SUBJECT: Discusses organizational structure changes made to enhance  
 managerial accountability of various groups in nuclear  
 operations dept. Marked-up Tech Spec Figures 6.2-1 & 6.2-2  
 encl. Fee paid.

Subject: Virgil C. Summer Nuclear Station  
Docket No. 50/395  
Operating License No. NPF-12  
Technical Specification  
Organizational Structure Changes

South Carolina Electric and Gas Company (SCE&G) has determined some organization changes are required to enhance managerial accountability of the various groups in the Nuclear Operations Department. In addition, several editorial changes to Figures 6.2-1 and 6.2-2 are being made to reflect correct titles and functional alignments. Please refer to both the attached marked-up copies of Figures 6.2-1 and 6.2-2, provided for illustrative purposes, and the smooth retyped versions of these figures.

FIGURE 6.2-1  
SOUTH CAROLINA ELECTRIC AND GAS COMPANY  
VIRGIL C. SUMMER NUCLEAR STATION  
OFF SITE ORGANIZATION

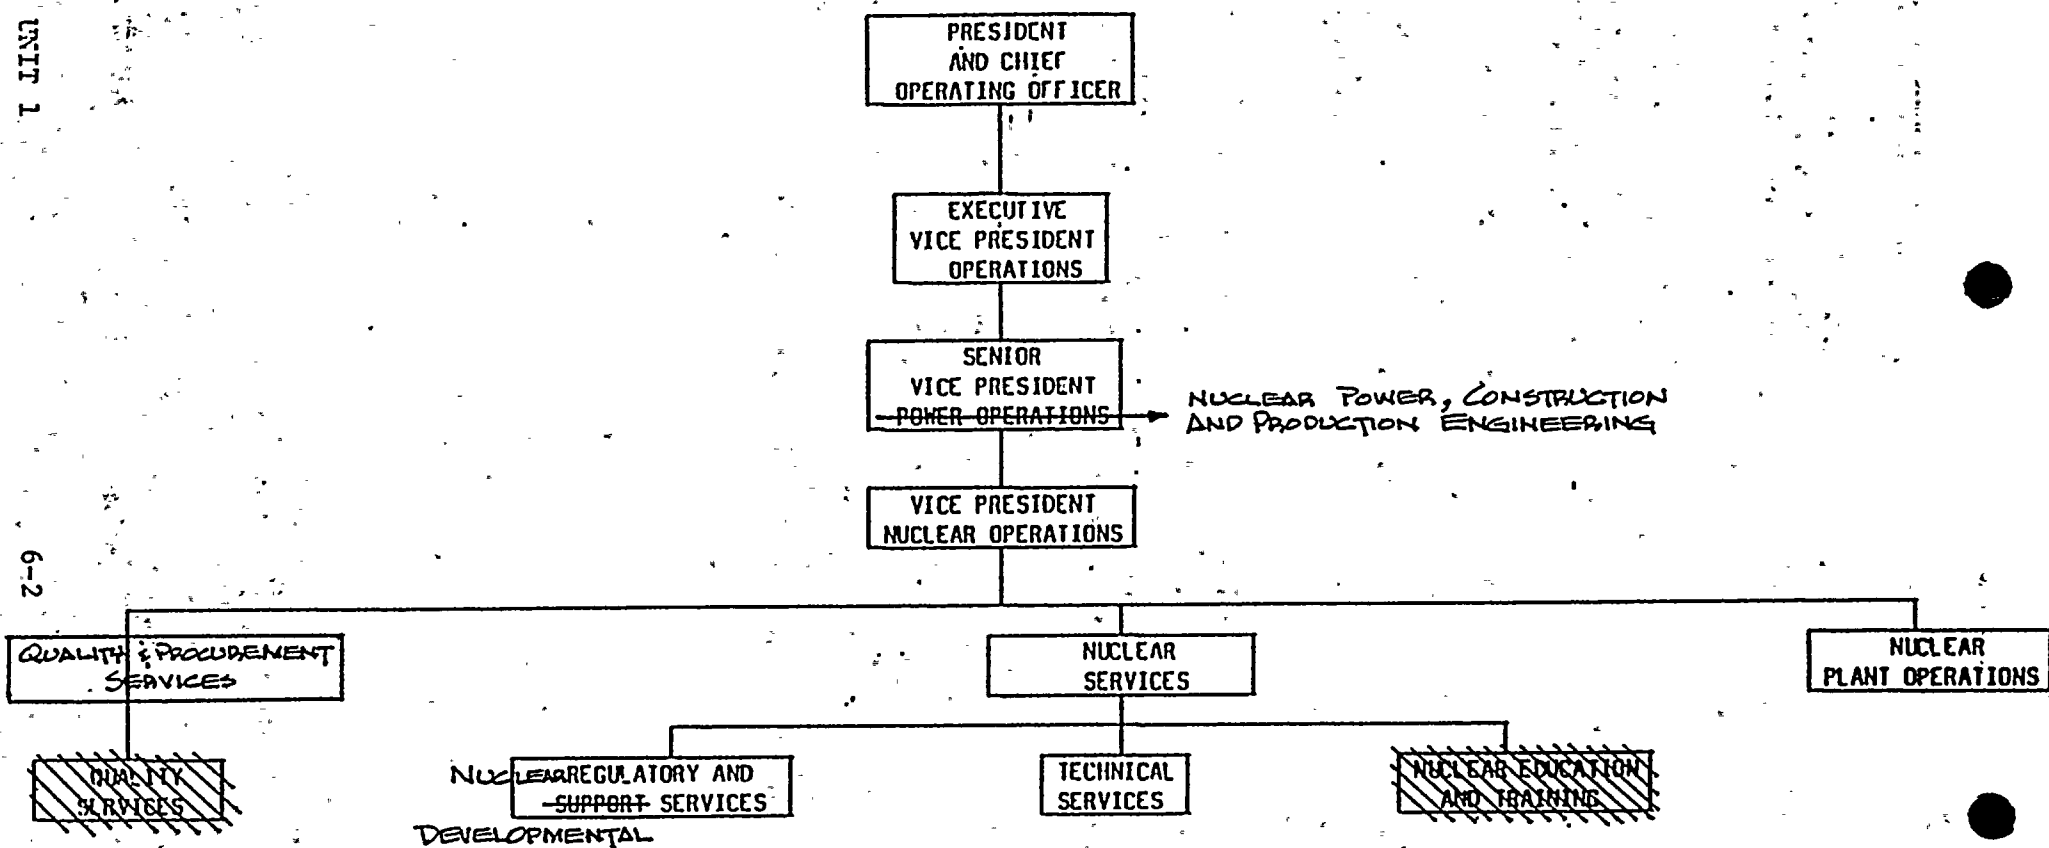
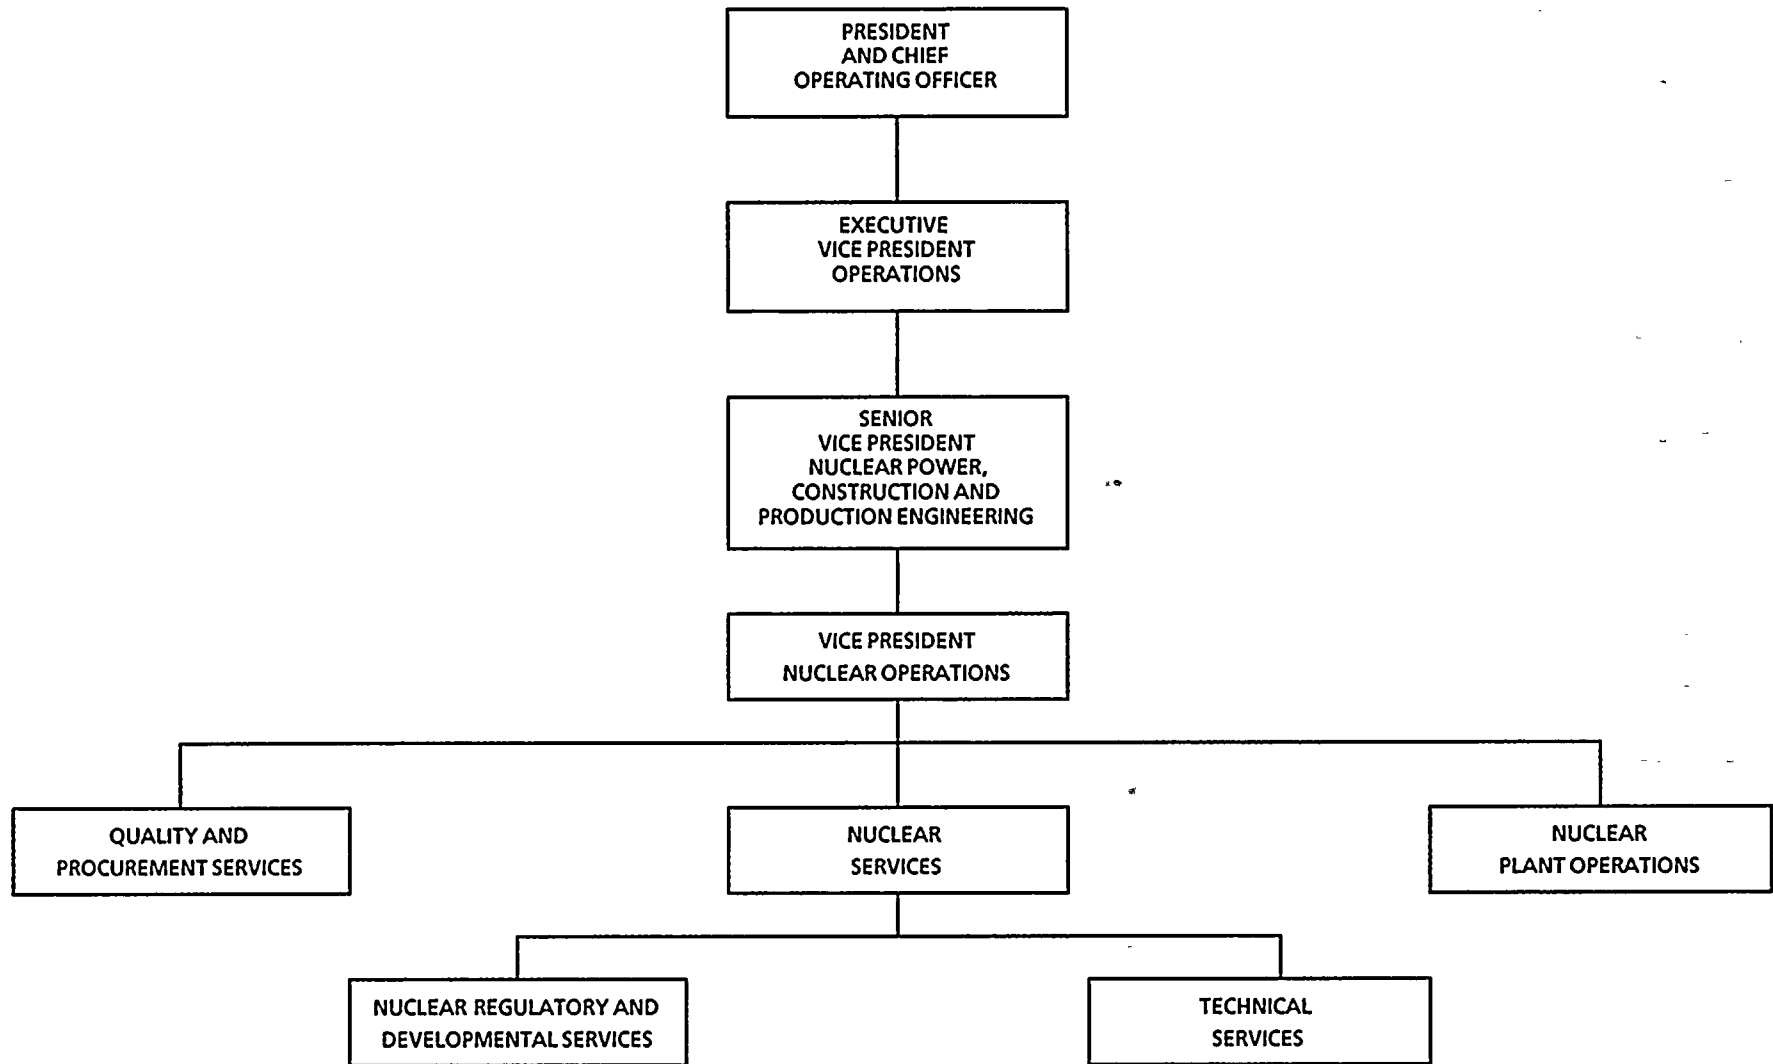
Organizational changes concerning upper management have been made in recent months; however, these changes did not alter the organizational structure under the Vice President, Nuclear Operations. As shown in Figure 6.2-1, this restructuring changed the title of Senior Vice President, Power Operations, to Senior Vice President, Nuclear Power, Construction and Production Engineering.

In the Nuclear Services Division, shown on Figure 6.2-1, three group manager positions have been combined into two, resulting in greater efficiencies and tighter spans of control. Regulatory and Support Services, and Nuclear Education and Training are combined under one group manager, that of Nuclear Regulatory and Developmental Services. This position has the Manager, Nuclear Licensing; Manager, Corporate Health Physics and Environmental Programs; Manager, Nuclear Operations Education and Training; and Manager, Nuclear Technical Education and Training reporting to him. There are no changes under Technical Services.

On Figure 6.2-1 the Quality Services Organization now includes the Procurement Group of the Nuclear Operations Department. The title of Quality Services is changed to Quality and Procurement Services, now headed by a director who has the Manager, Materials and Procurement; Manager, Quality Assurance; and Manager, Quality Control reporting to him.

FIGURE 6.2-2  
VIRGIL C. SUMMER NUCLEAR STATION  
FUNCTIONAL ORGANIZATION

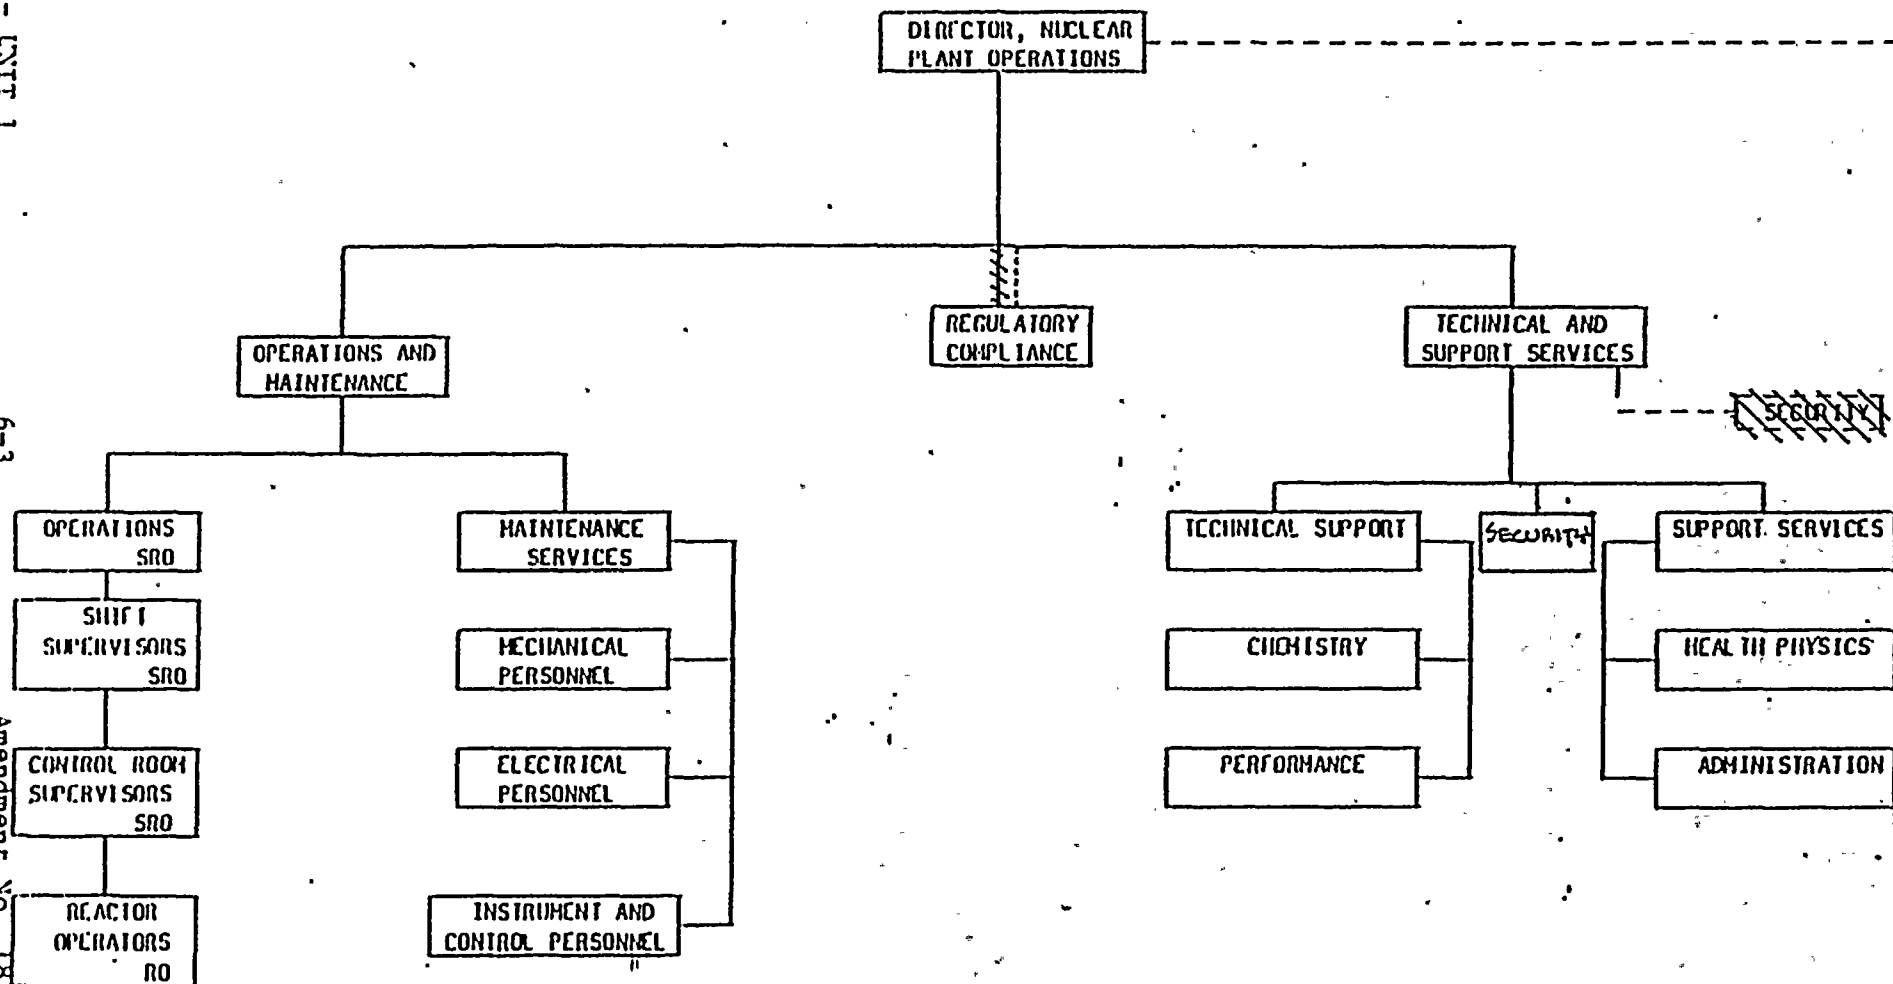
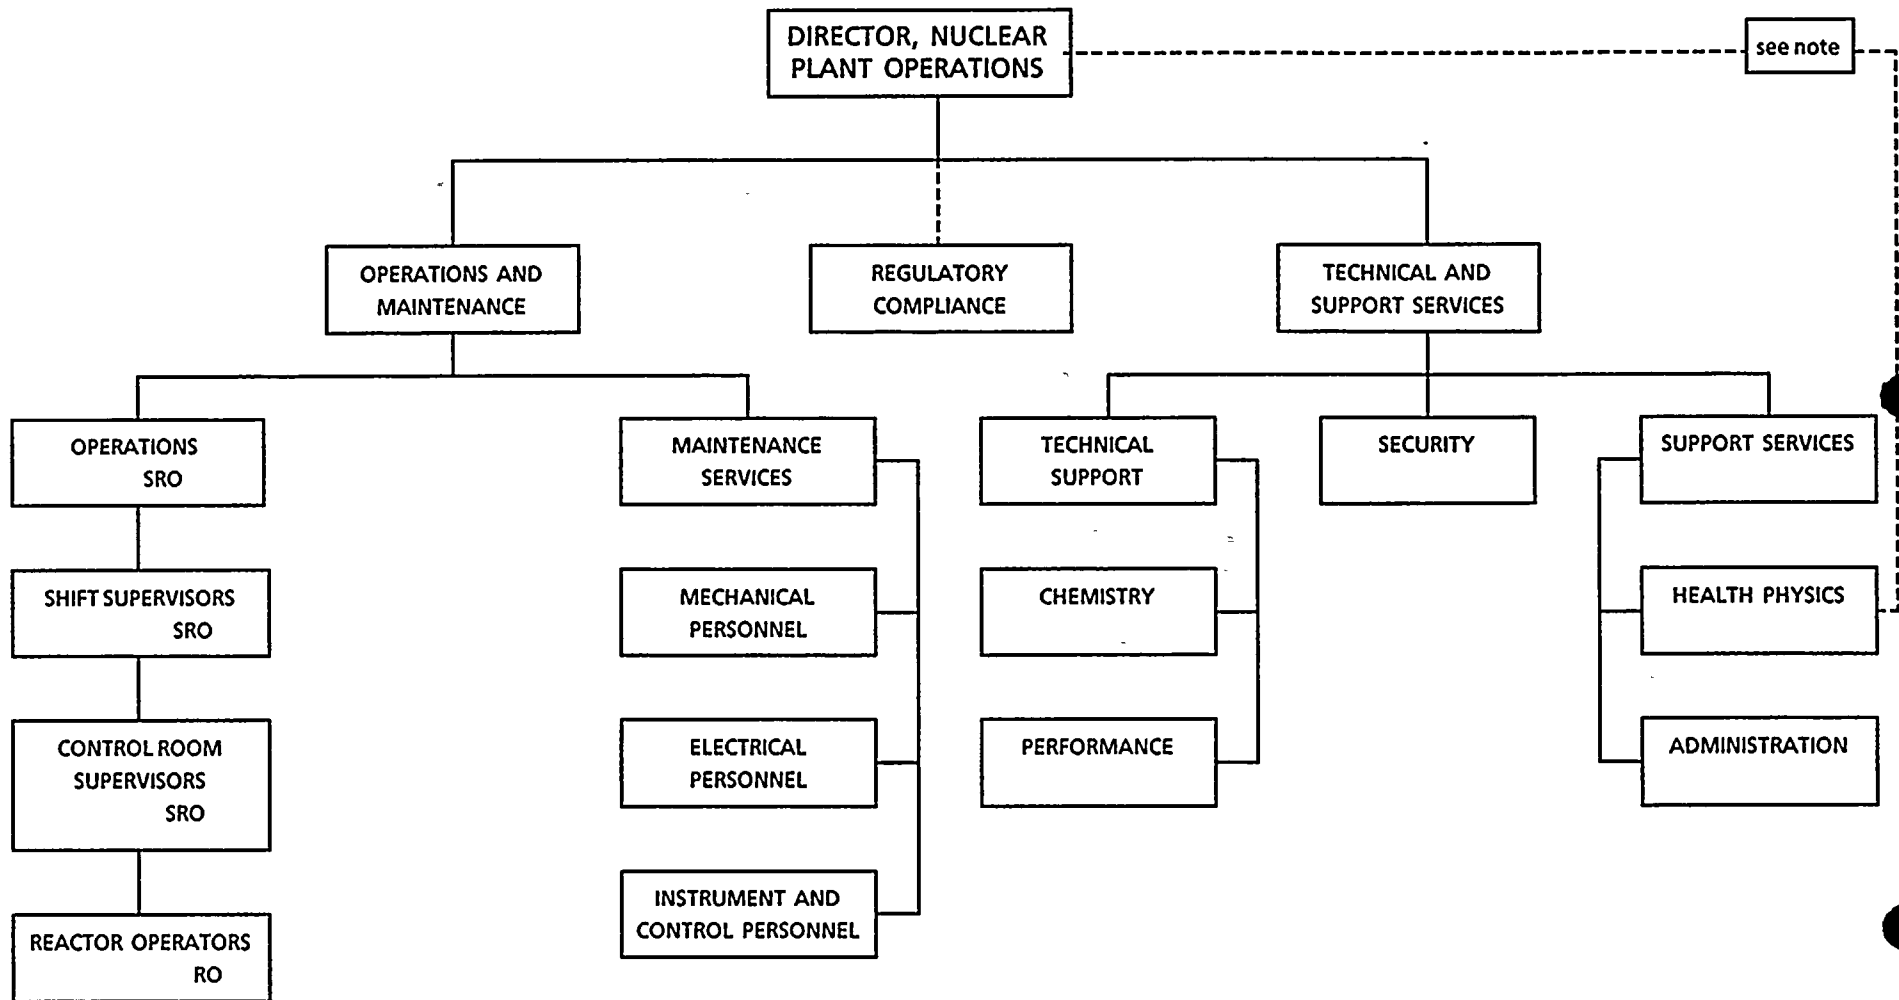
On Figure 6.2-2 the Security Organization has been reporting administratively offsite and functionally onsite to the Group Manager, Technical and Support Services. This organization now reports administratively and functionally to Technical and Support Services. The Regulatory Compliance Group will now report offsite to the Manager, Nuclear Licensing in the Nuclear Regulatory and Developmental Services Organization. Functionally, this group will remain at the Station and fully support the Director of Nuclear Plant Operations.
